ANN ARBOR HISTORIC DISTRICT COMMISSION

Staff Report

ADDRESS: 122 South Seventh St, Application Number HDC14-017

APPLICATION: The applicant seeks HDC approval to install three skylights on the north-facing roof surface, and replace a rear door with a wood single-light door.

Proposed FL2	DATE 2/3/14	Dave Lewis 122 S. Seventh		2200 DEXTER AVE. ANN ARBOR, MI 48103 Phone (734) 747-7414
	SCALE 1/4" = 12"

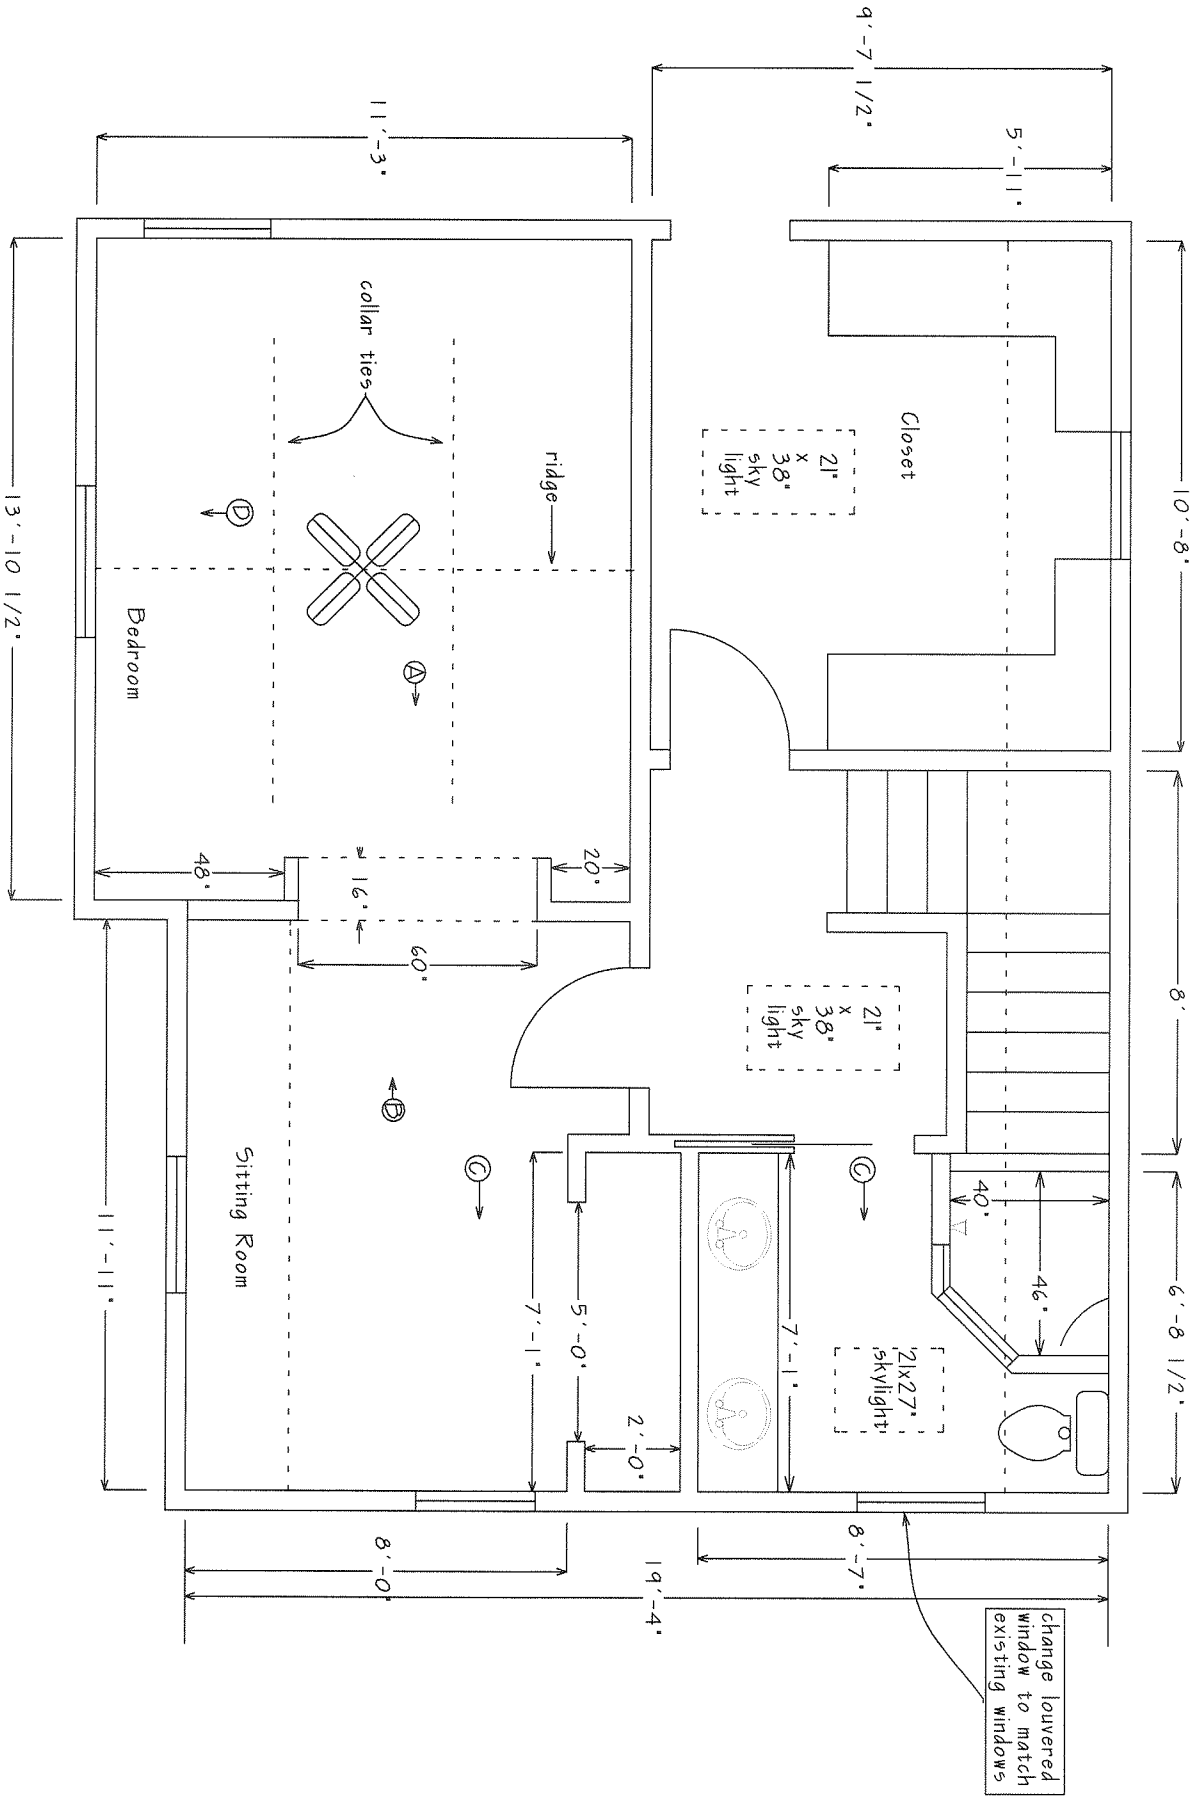
3. A replacement bathroom window is shown on the floorplan—this was already approved at the staff level.
4. Staff believes the work, as proposed, is compatible with the existing structure, neighboring buildings, and the surrounding historic district, and meets the Secretary of the Interior's Standards and Guidelines and the *Ann Arbor Historic District Design Guidelines*:

change lowered window to match existing windows
